**Package C-2: Tender No. HORC/HRIDC/C-2/2022**

**REPLIES TO PRE-TENDER QUERIES, Part- 3: 01.08.2022**

C-2: Composite Contract Package in connection with laying of New BG Double Railway Line of HORC project for:  
(i) Design and Construction of Civil Works (Earthwork, Bridges, Station Buildings, Retaining Walls and other miscellaneous Works) from Km 55.60 to Km 61.50 and its connectivities to IR network from New Patli to Patli & New Patli to Sultanpur including modifications in Sultanpur station yard,  
(ii) Design, Supply, Installation, Testing & Commissioning of OHE (1x25 kV) and General Electrical services from Km 49.70 to Km 61.5 and its connectivities to IR network from New Patli to Patli & New Patli to Sultanpur including modifications in Sultanpur station yard and  
(iii) Design, Supply, Installation, Testing & Commissioning of Signalling & Telecommunication from Km 49.70 to Km 61.5 and its connectivities to IR network from Manesar to Patli and New Patli to Patli & New Patli to Sultanpur including modifications in Patli and Sultanpur station yards.

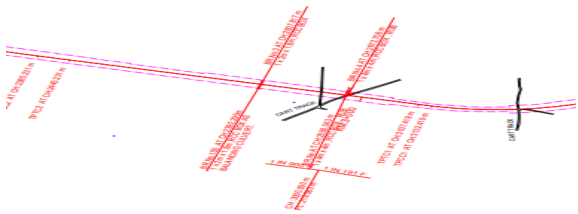
| Query No. | Reference to Tender Document (Clause/ Para No. & Page No.)                               | Brief Description of Clause /Para No.   | Query Raised  | Reply of HRIDC  |
|-----------|--|---|---|---|
| 4.        | Drawing No: GC-HRIDC-C2-DRG-BRD-GAD-NP-P-3_A0, P-4_A0, P-6_A0 & P-7_A0                   | The Span details of following Minor Bridges/RUB are different in L-Section and Drawing/Documents for section New Patli to Patli:-<br>1) BR No-3 (Span details in L-Section- 1x4x2.5, whereas in Drg & Document- 1x5x3)  | Please confirm the Span details of mentioned Minor Bridges/RUB.         | Refer Annexure F-1, of Section VII-2: Functional (Civil), Attachment 3 of Corrigendum No. 5 and Tender drawings in Section VII-11: Tender drawings and documents of Final                                   |

| Query No. | Reference to Tender Document (Clause/ Para No. & Page No.) | Brief Description of Clause /Para No.  | Query Raised  | Reply of HRIDC   |
|-----------|--|--|---|--|
|           |  | 2) 2) BR No-4 (Span details in L-Section- 1x2x1.8, whereas in Drg & Document- 1x2x2)<br>3) 3) BR No-6 (Span details in L-Section- 2x5x5, whereas in Drg & Document- 1x5x5)<br>4) 4) BR No-7 (Span details in L-Section- 1x2x1.8, whereas in Drg & Document- 1x2.5x3)   |   | Tender Documents, Corrigendum No. 6.   |
